**CHARTER TOWNSHIP OF VAN BUREN
PLANNING COMMISSION AGENDA
Wednesday, February 13, 2019 – 7:30 PM
Van Buren Township Hall
46425 Tyler Road**

DATE: February 9, 2019
TO: Planning Commission
FROM: Ron Akers, AICP – Director of Planning & Economic Development
RE: SPR 19-005 Site Plan Amendment for Trowbridge Homes regarding Architectural Elevations in the Cobblestone Ridge Development.

DATE: February 9, 2019
TO: Planning Commission
FROM: Ron Akers, AICP – Director of Planning & Economic Development
RE: SPR 19-004 Site Plan Amendment for BK Development in Cobblestone Creek Review.

THE GREENBRIAR

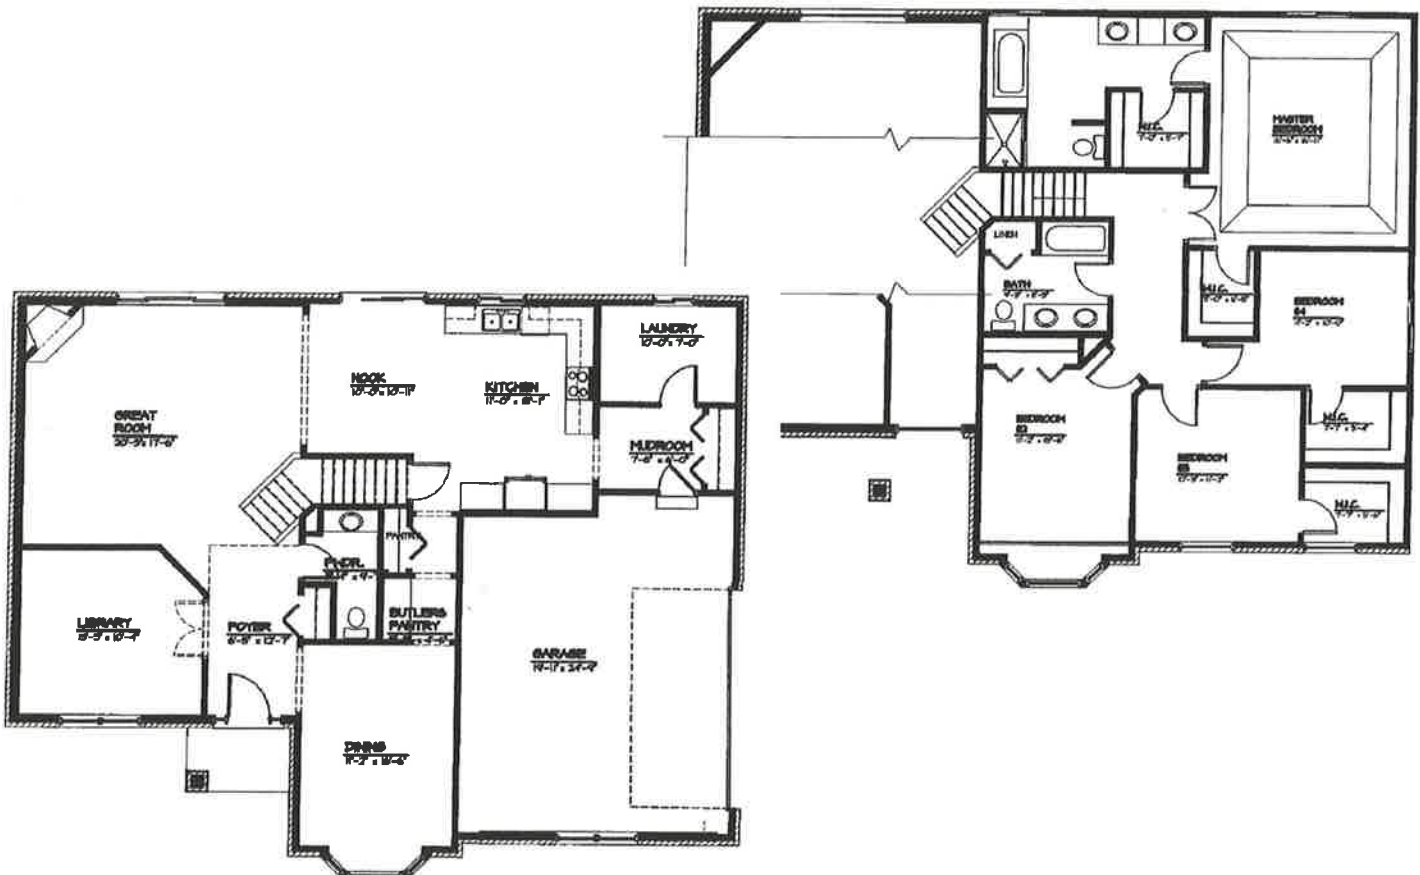
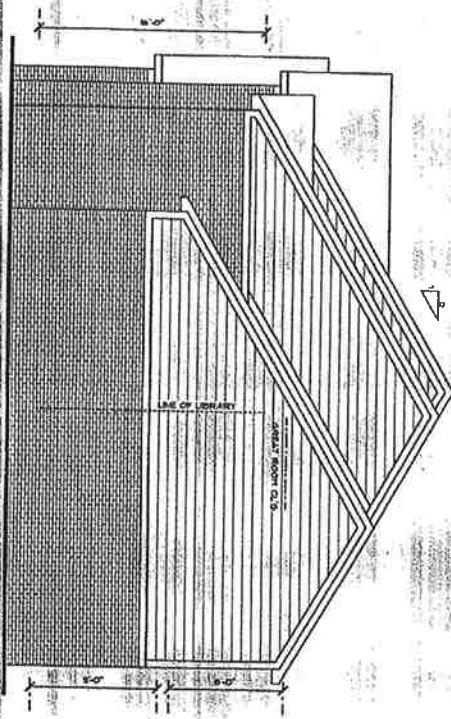
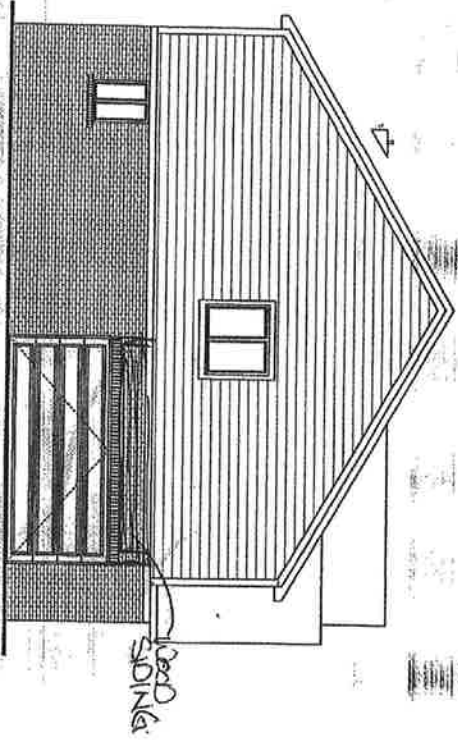
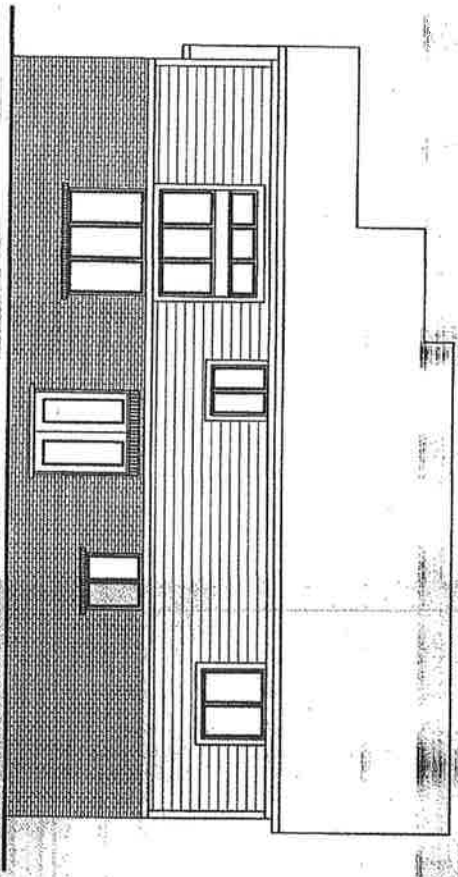
The Greenbriar elevation has a note on top of the front elevation. It appears that a note was placed on top of it when it was copied. Please provide a revised drawing of the Greenbriar which is not covered and clearly depicts the front elevation.

1. Depictions of the width and length of each of the proposed homes to be built to determine that they will fit on a standard lot.
2. The proposed square footage of the Aspen, Fairfax, and Greenbriar plans to verify that these models meet the minimum floor area requirement of 1,800 square feet.
3. Revised elevations for the Fairfax and Winnick plans in order to demonstrate that these elevations meet the minimum 50% brick façade requirement exclusive of doors and windows.
4. Please provide a version of the Greenbriar plans which clearly depicts the elevations without obstruction.

THE STANSFIELD "A"

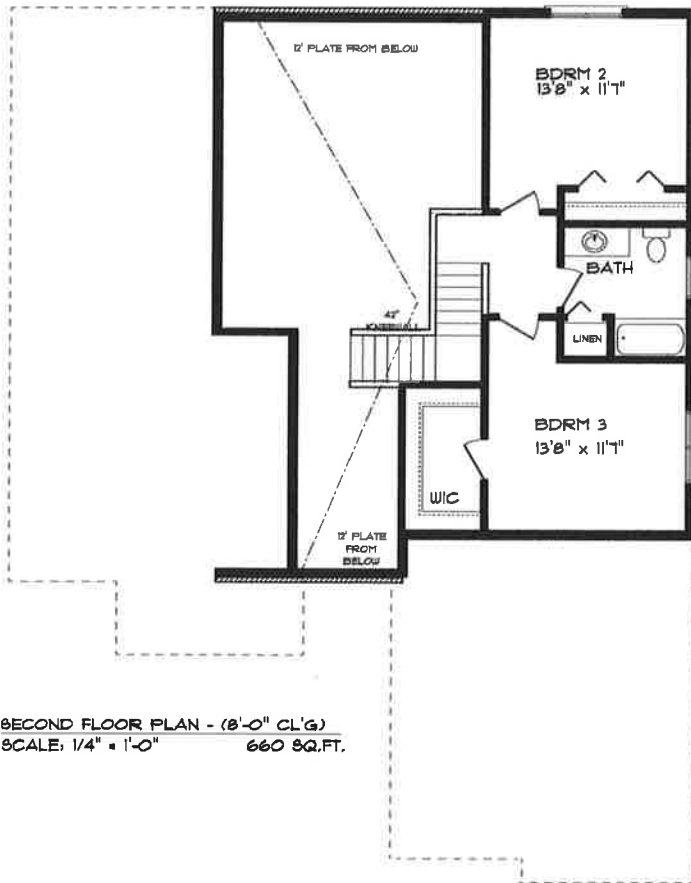
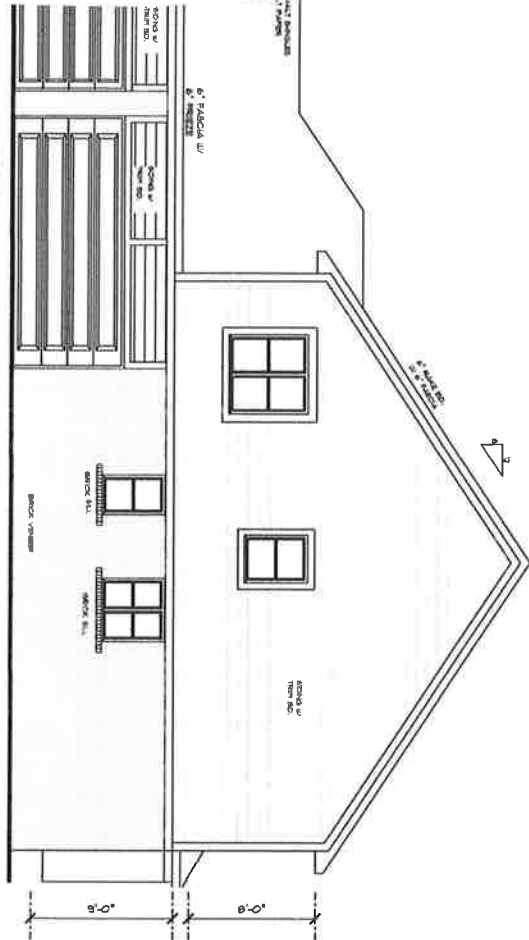
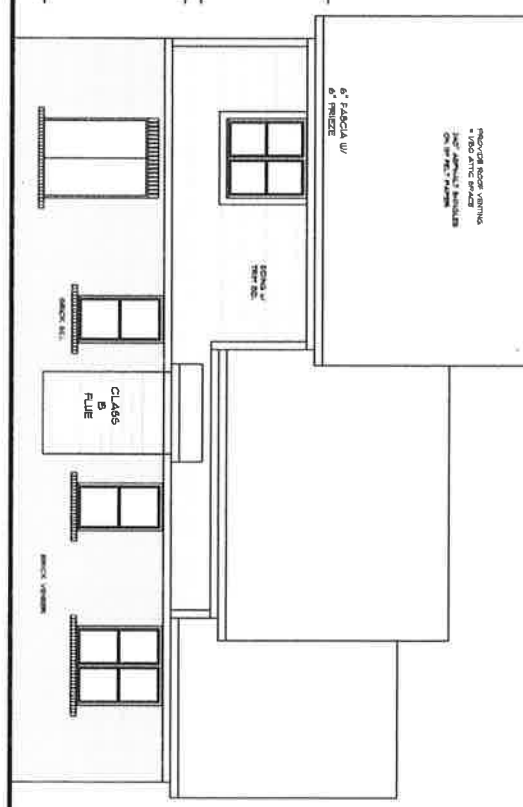
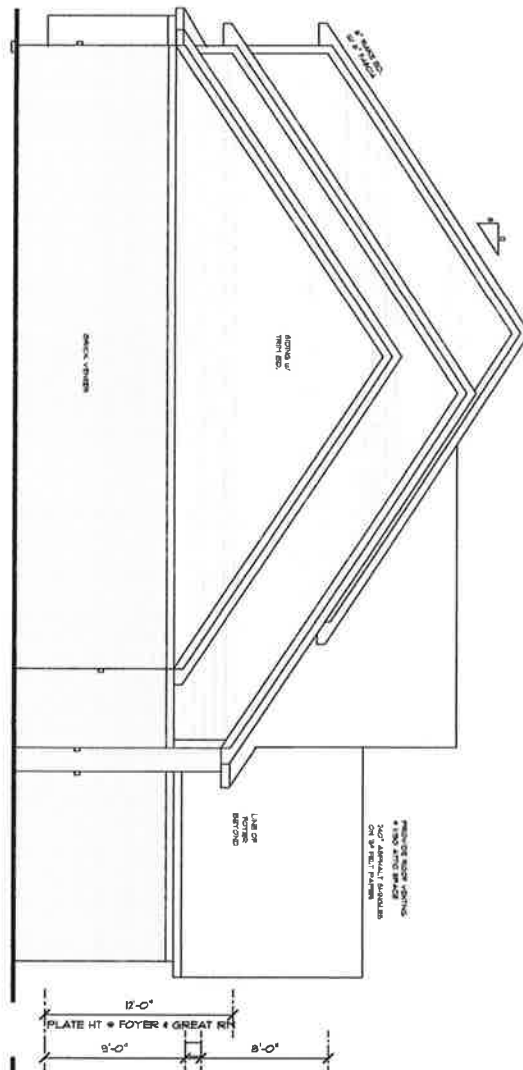
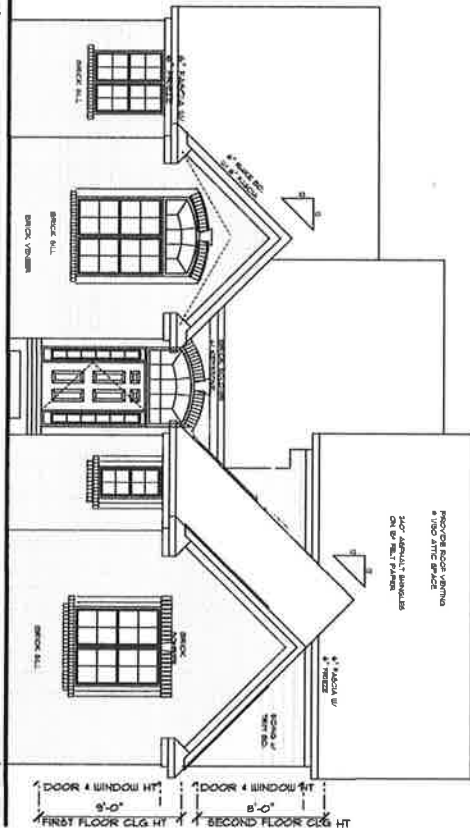
The applicant will need to provide additional information regarding the square footage of these models prior to approval. The models Golfview, Stansfield A & B, and Winnick all met this requirement.
